**DATE:** 11.05.2018  
**TO:** ProTrak  
**FROM:** Mitesh Baxi  
Traffic Engineering

■ **PEACE BAPTIST CHURCH [TRC Plan Review #2]**

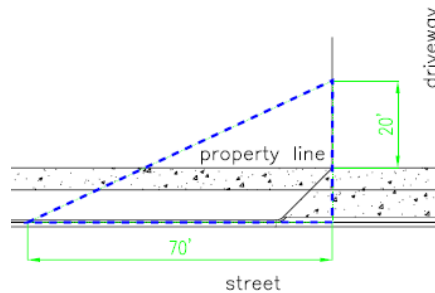
1. The City's 20'x70' sight distance triangle is not shown correctly on the site plan. Please revise as per the image below. [[Sec.18-529\(c\)\(3\)CofW LDC](#)]
